ERRATA FOR EDITION 3

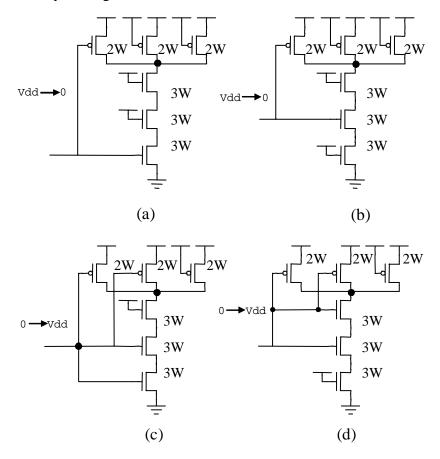
33. p. 304, for clarity, the figures in P6.4 should be shown as follows:

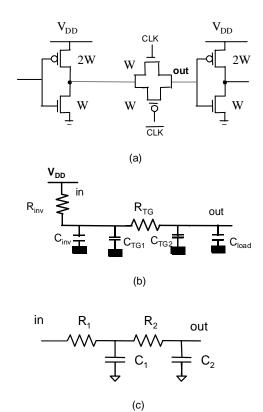
34. p. 307, replace " $\mathbf{LE_R}$ " with "**rising LE_R**", and also replace " $\mathbf{LE_F}$ " with "**falling LE_F**". Furthermore, Figure P6.10 should have the label F removed from the output of the schematic. This is confusing for the reader due to the use of $\mathbf{LE_F}$.

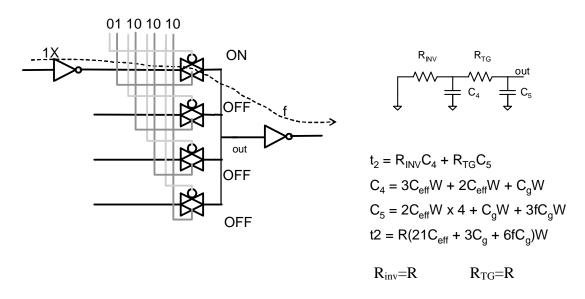
35. p. 329, Figure 7.18(a) should have a label "Out" as shown below:
